## SVT geometry and integration issues

**Georg Viehhauser**

L3

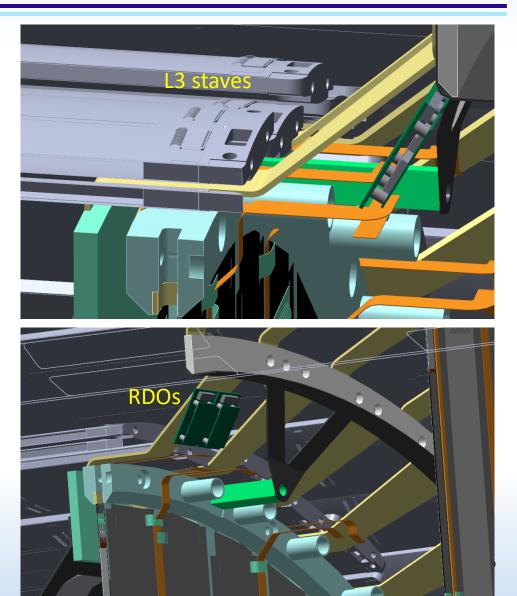
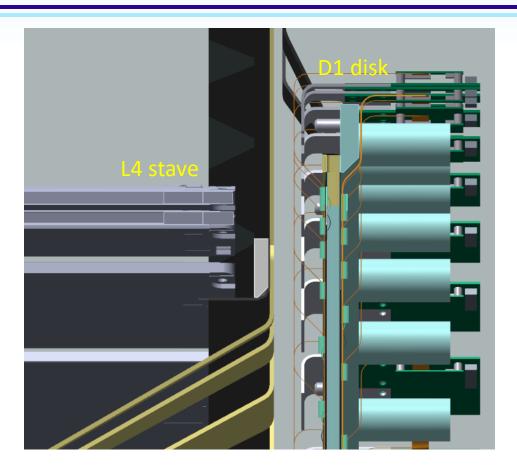
- This stave model has the current end plug (~10 mm)
- Support cones (spokes) not yet optimized
- No detail on stave support and coupling of air channel
- This support cone geometry does not work well for stave installation (would have to fiddle stave to behind the cylindrical section

- It appears that L4 staves end well before D1
  - Seems to be a comfortable amount of space
- But, no airchannels, FPCs & RDOs in the model yet
